# Proposed modification of Carrier Status Generation state diagram

**Eric Lynskey**  
**IEEE 802.3av Task Force Meeting**  
**July 15-17, 2008**  
**Denver, Colorado**

Figure 92-5—Carrier Status Generation state diagram

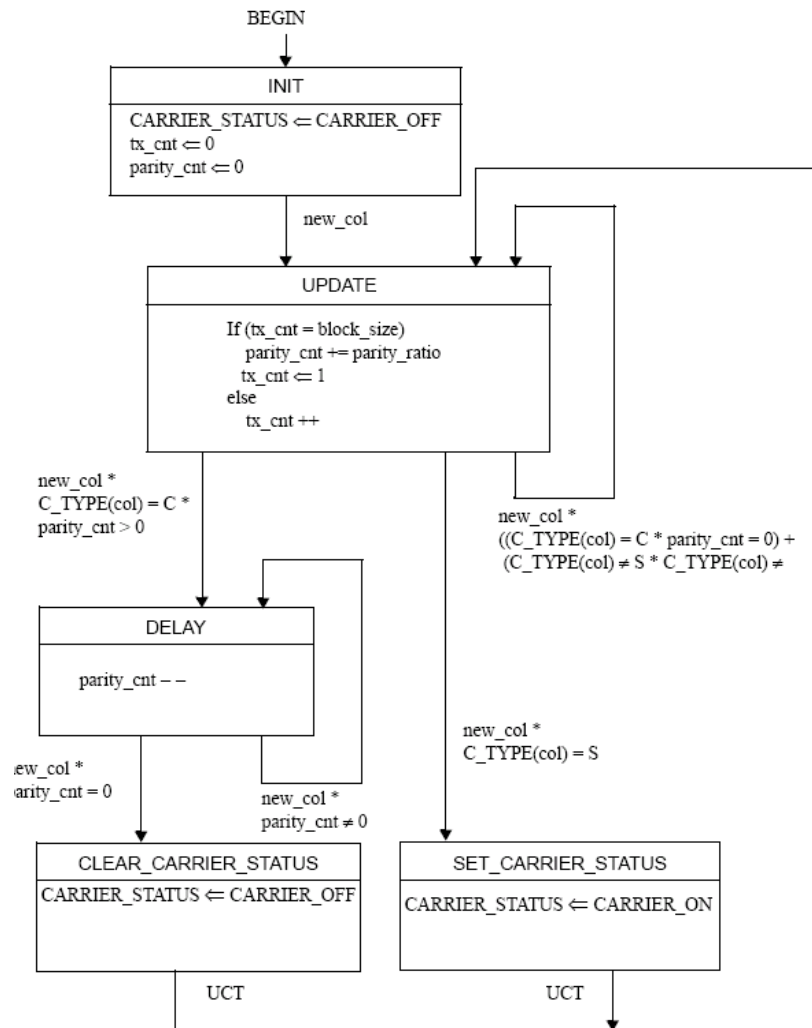
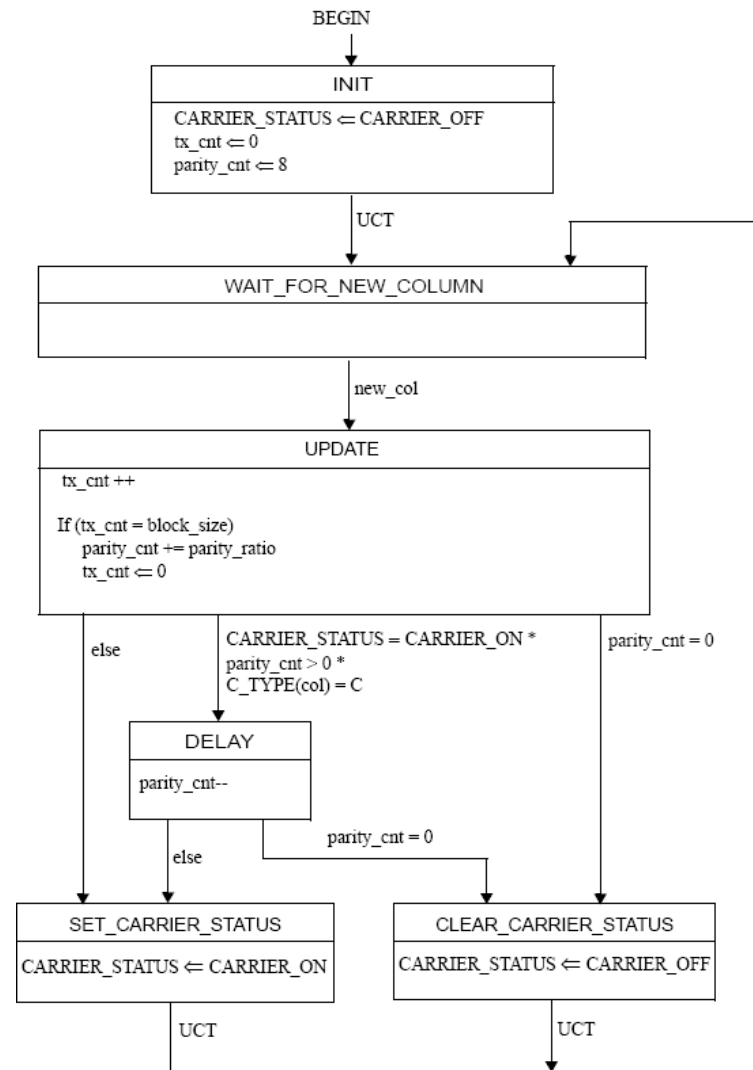
## Problem: Diagram sometimes force extra IPG

- Assume 64-byte frame, parity\_cnt = 0, tx\_cnt = 1.
- A 64-byte frame has 16 columns of data, 2 columns of preamble, and 3 columns of IPG, 21 total.
- When the "S" column is received, CARRIER\_STATUS is set to CARRIER\_ON, tx\_cnt = 2. State diagram will loop around through UPDATE state until frame is done.
- At end of the frame, tx\_cnt = 22 and parity\_cnt = 0.
- Since parity\_cnt = 0, the state diagram will continue to loop around in the UPDATE state until tx\_cnt=54.
- During this time CARRIER\_STATUS is still equal to CARRIER\_ON and no new frame can be sent.
- An extra large IPG will be enforced by CARRIER\_STATUS for all frame lengths < 216 bytes.

- Instead of being set at the beginning of each frame, CARRIER\_STATUS is set only when needed.
- This allows multiple small frames to be sent without enforcing gap for parity between all frames.
- Greatly improved performance for small frames.
- Simulation shows delay variability that is provided to MAC is 32 bytes (sometimes there is one more set of 4 columns of IPG to delay just when frame arrives).

- Carrier Status Generation state diagram was modeled.
- Results showed unnecessary delay for some frame lengths.
- Improvements to state diagram have been proposed.
- **Propose that new diagram is used for D2.0.**

- Wait until a new column is available for transmission across XGMII.
- Keep track of how many columns have been transmitted by updating tx\_cnt. Keep track of how many parity columns need to be marked by updating parity\_cnt. For every 62 columns transmitted, mark 8 as parity.
- If parity\_cnt is 0, then set status to CARRIER\_OFF.
- If parity\_cnt is non zero and status is CARRIER\_OFF, then set status to CARRIER\_ON.
- If parity\_cnt is non zero and status is CARRIER\_OFF, and currently transmitting IDLE, then decrement parity\_cnt. If parity\_cnt reaches 0, then clear CARRIER\_STATUS. Otherwise, reassert it.
